**Economic and Social Council**

World Forum for Harmonization of Vehicle Regulations**Working Party on Lighting and Light-Signalling****Sixty-eighth session**

Regulation No. 10 (Electromagnetic compatibility)**Proposal for the 05 series of amendments to Regulation
No. 10 (Electromagnetic compatibility)****Submitted by the experts from OICA***

Figure 3
Vehicle in configuration "REESS charging mode" coupled to the power grid

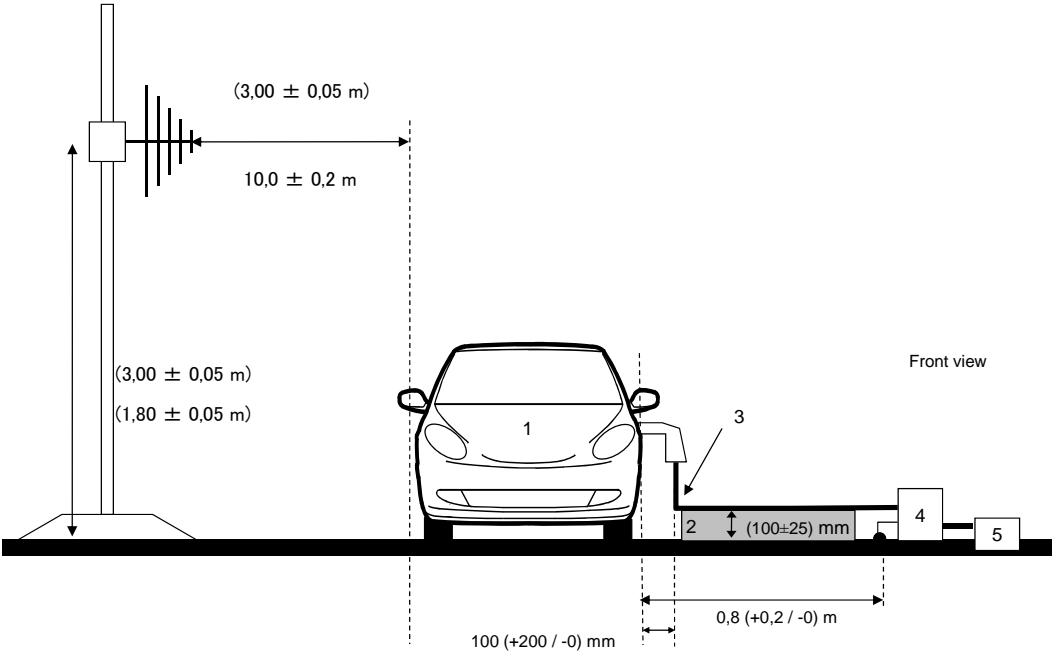
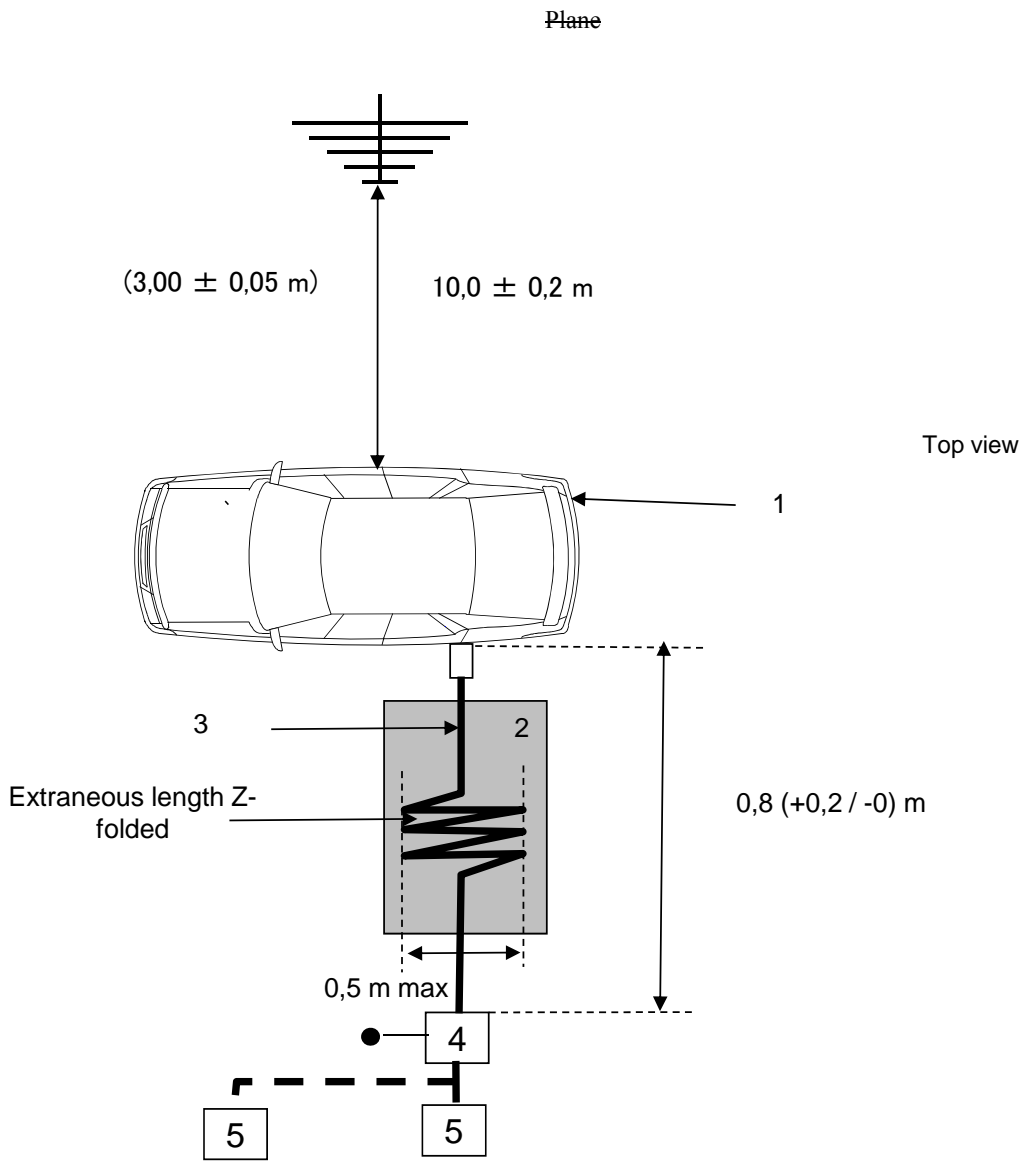
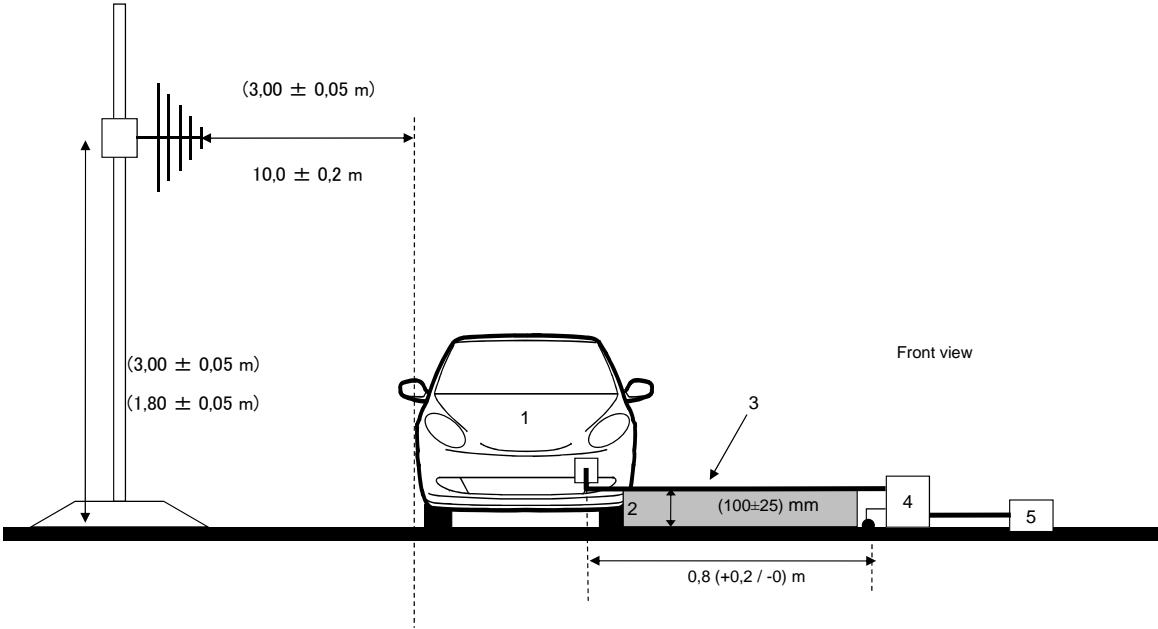
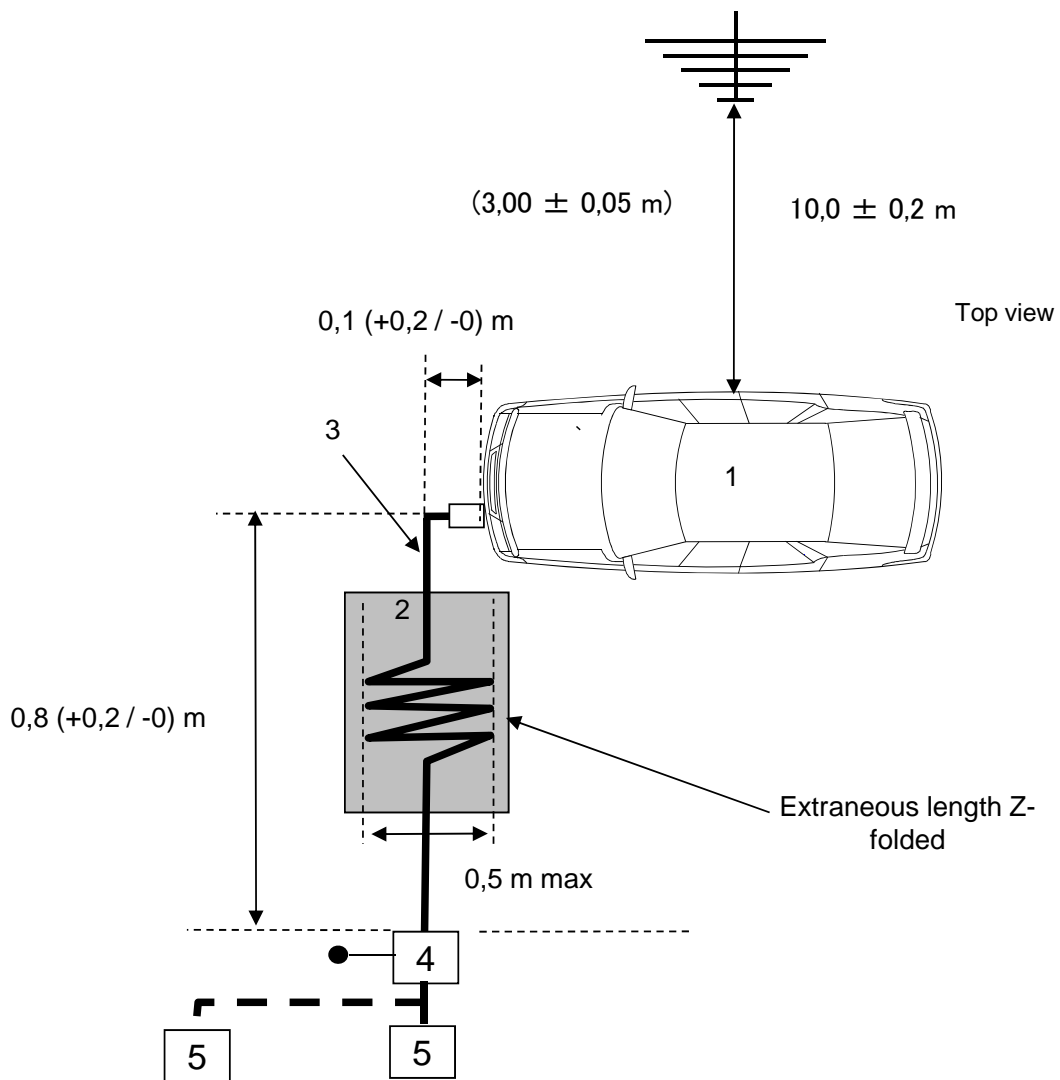
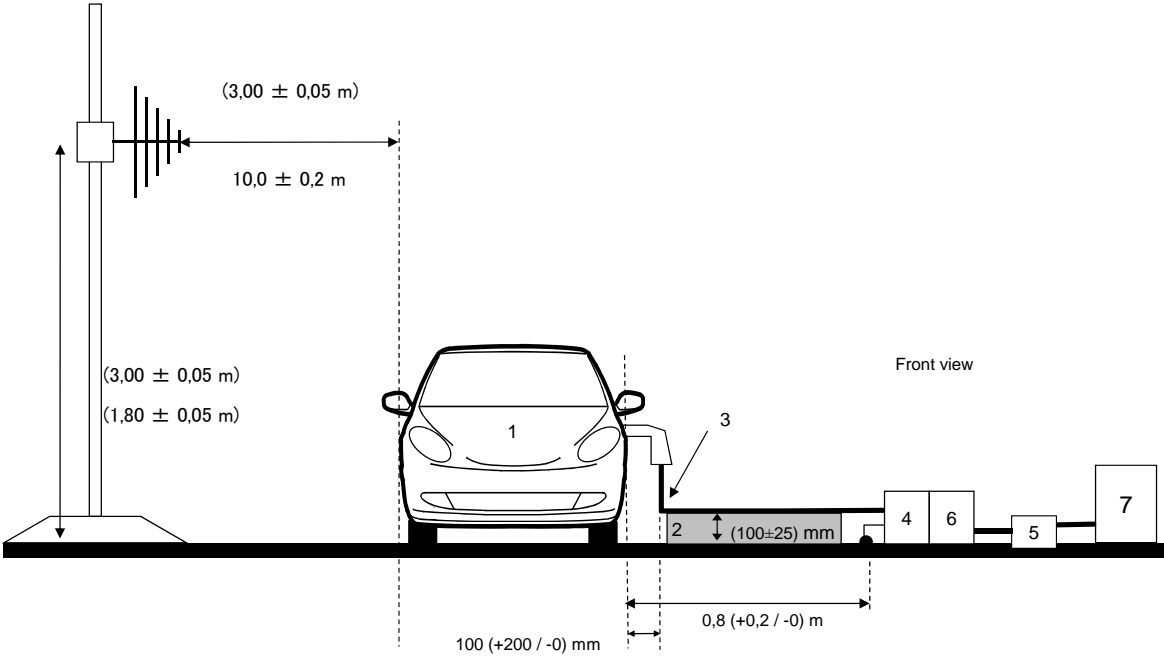
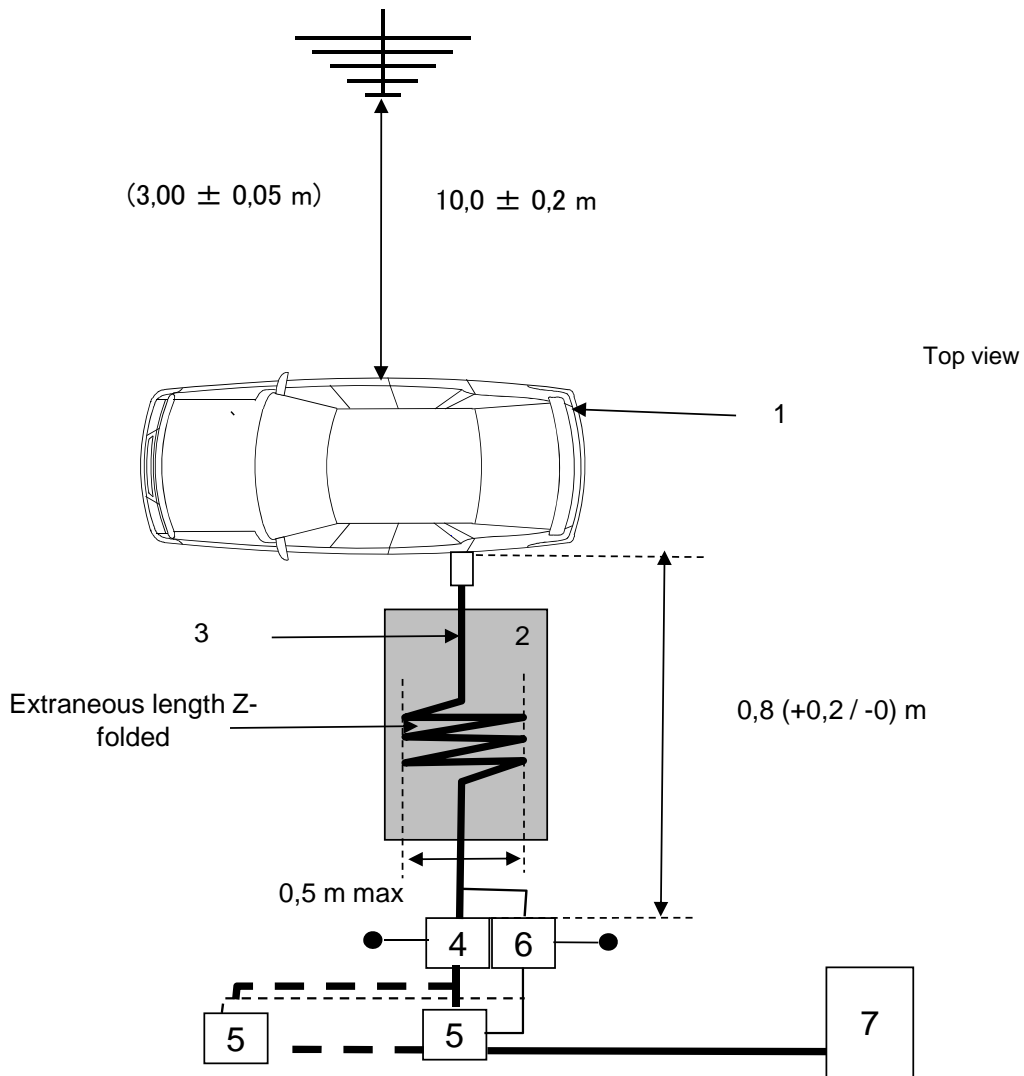
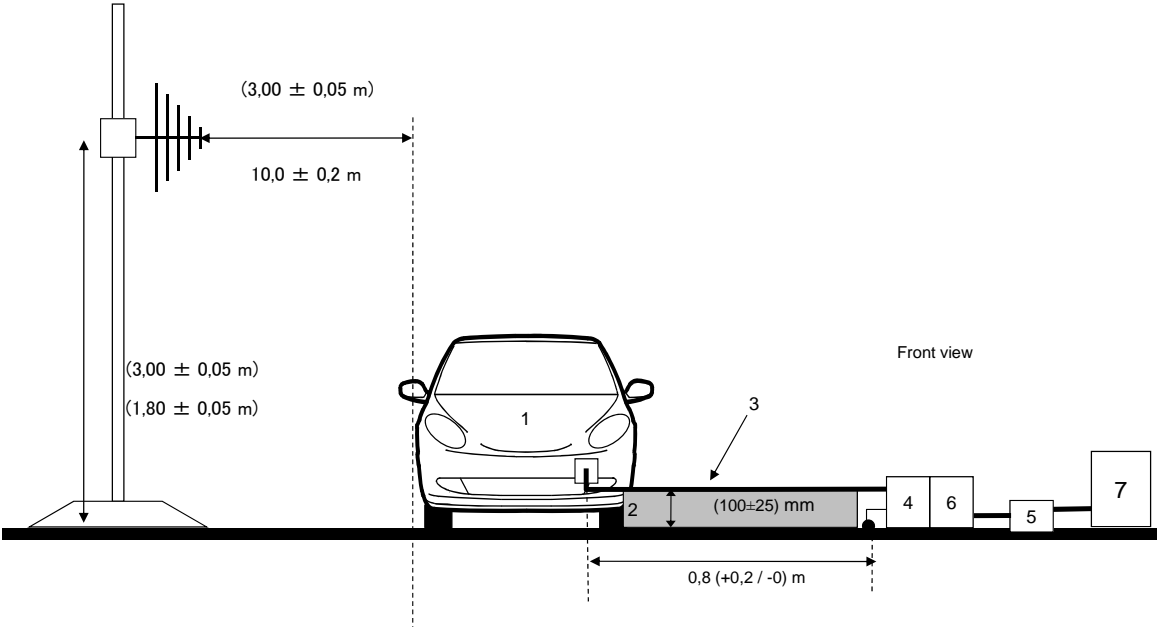
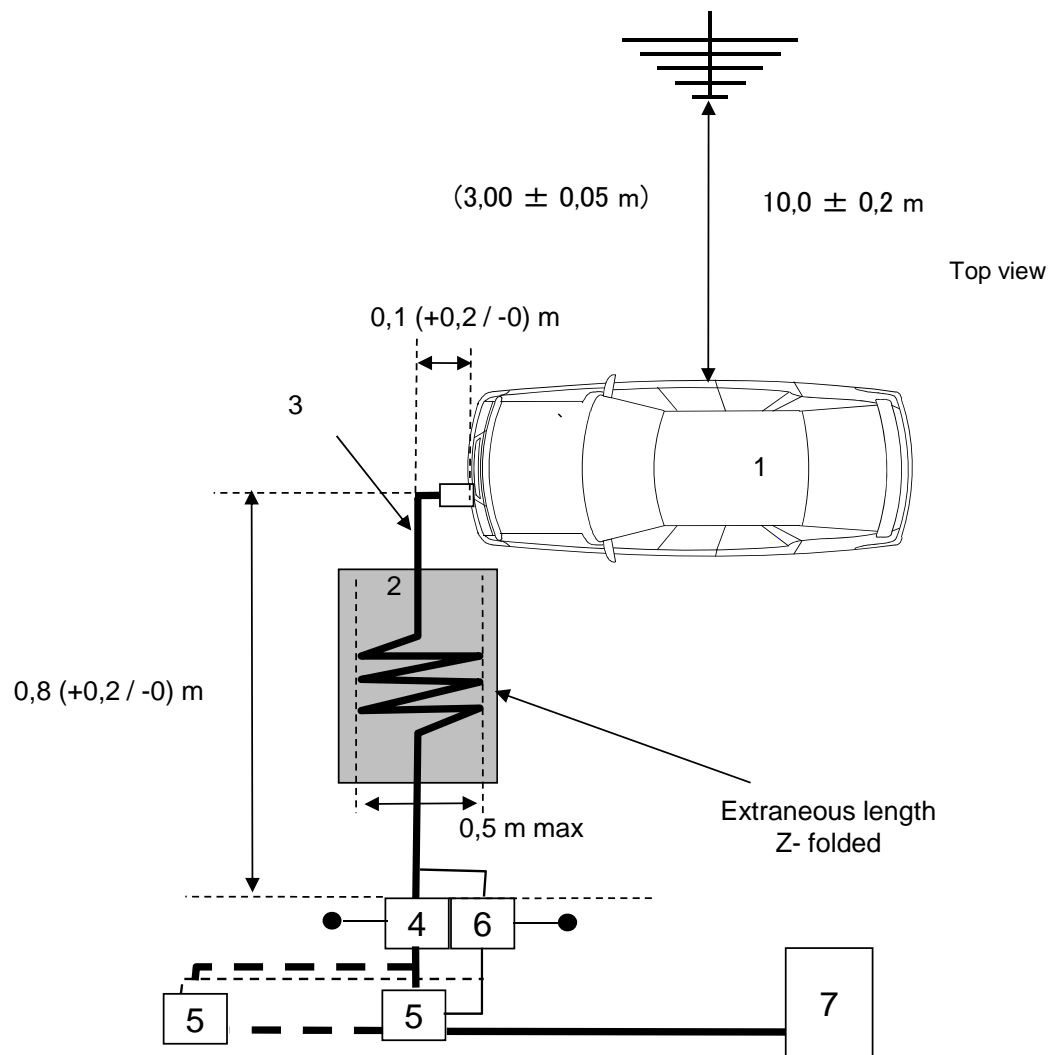
The test set-up for the connection of the vehicle in configuration "REESS in charging mode coupled to the power grid" is shown in Figure 3a to 3h (depending of AC or DC power charging mode, location of charging plug and charging with or without communication) of Appendix 1 to this annex.
